# PLAN COMMISSION STAFF REPORT

**Agenda Item:** PC 25-012

**Application Type:** Development Plan

**Summary:** Applicant is requesting review and consideration for a single-site Development Plan to include employee off-street parking, vehicular emergency exit connection, screening, landscaping, lighting, and refuse area at Crew Car Wash located at 111 Ridge Road.

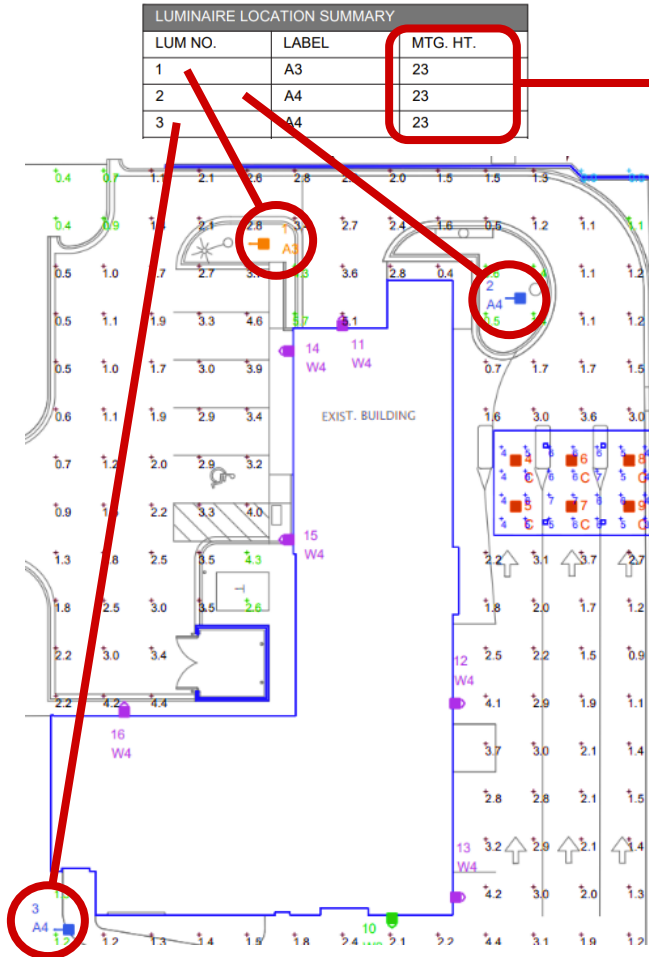
However, additional information is required regarding the proposed pole lights. Manufacturer specs for the pole lights have not been provided and all proposed lighting will need to comply with the Character Based Zoning Code or secure a BZA Variance approval.

Proposed lighting does not meet the height requirement, and the manufacturer specs have not been submitted to confirm head type compliance.

Proposed wall lighting complies with the full cut off or fully shielded and the manufacturer specs can be reviewed in Exhibit F

Staff finds the applicant and interested parties have submitted a complete application, including limited power of attorney affidavit, as well as fulfilling the Public Notice Requirements. However, staff finds that additional supporting document(s) are required to confirm all proposed lighting standards comply with the character based zoning code height requirements and lighting head type. Staff is requesting the manufacturer lighting specs for the following manufacturer / lighting specs:

- Cree Inc. / OSQ-ML-C-XX-XX + OSQM-C-6L-30K7-3B-UL-NM-XX-Q1
- Cree Lighting / OSQ-ML-C-XX-XX + OSQM-C-16L-30K7-4B-UL-NM-XX-Q1
- CREE, INC. / CAN-304-PS-RS-04-E-UL-XX-700-30K-DIM (SET @ 1.1V)(SPECIAL ORDER)
- Cree Lighting / SEC-EDG-3M-WM-06-E-UL-XX-525-30K-DIM (SET @ 5.2V)

Staff recommends that the application be tabled to next month to allow the petitioner time to submit additional development plan supporting documents.
